VALLEJO SANITATION &  
FLOOD CONTROL DISTRICT

COMMENTS ON TENTATIVE ORDER FOR NPDES PERMIT NO.  
CA-0037699

**Detailed Comments on Vallejo Tentative Order**  
July 7, 2006

**Figure 1. TSS Correlates Well With BOD During Blending**

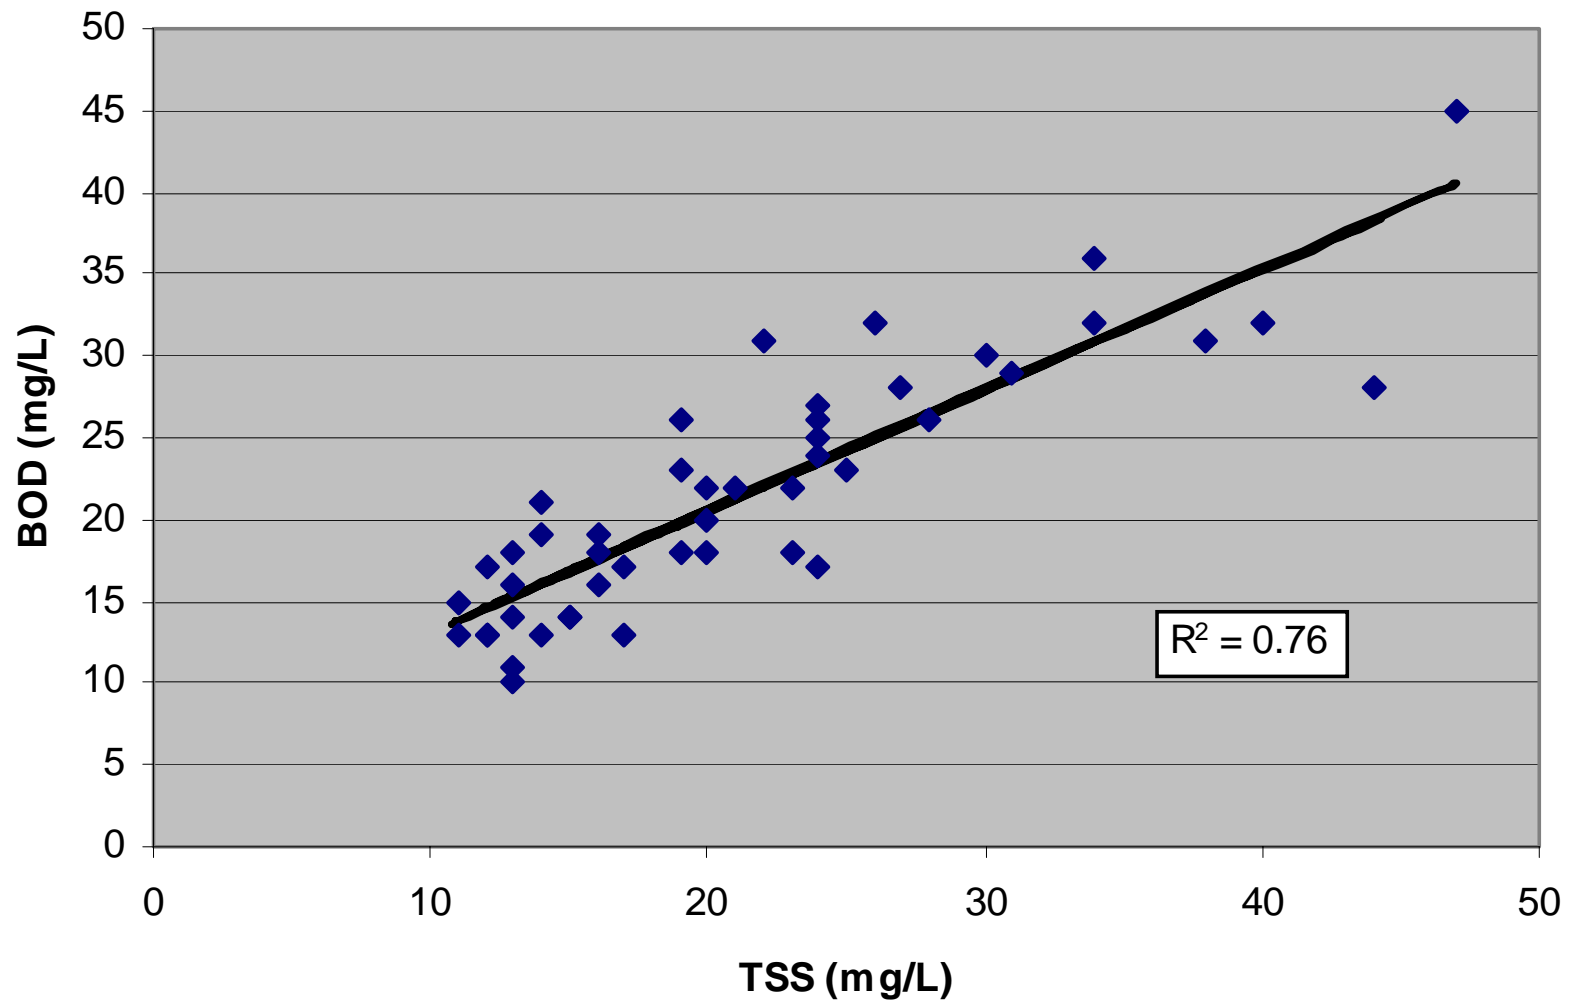
4. (Page E-9) The District requests that TSS be specified as the (sole) appropriate indicator of compliance for effluent limits during blending in this permit, because BOD correlates well with TSS and is therefore redundant. In addition, the BOD 5-day test is not a practical indicator during blending because blending happens on the order of hours instead of the several days it takes to get results back from a BOD test. Please see Attachment A for a scatter plot and correlation statistic ( $R^2$ ) for TSS vs. BOD. In addition, the District requests that coliform be removed from the list of parameters to analyze during blending, because coliform measured during blending has always been well below effluent limits (shown for 16 events in Attachment A), and standard operating procedures include increasing the chlorine from a routine average dosage of 3.0 mg/L up to 7.0 mg/L during blending. Coliform densities during blending, along with standard operating procedures for increasing chlorine dosage, are shown in Attachment A.

The District requests that language on page E-9 be revised as follows, as agreed at a meeting on June 27:
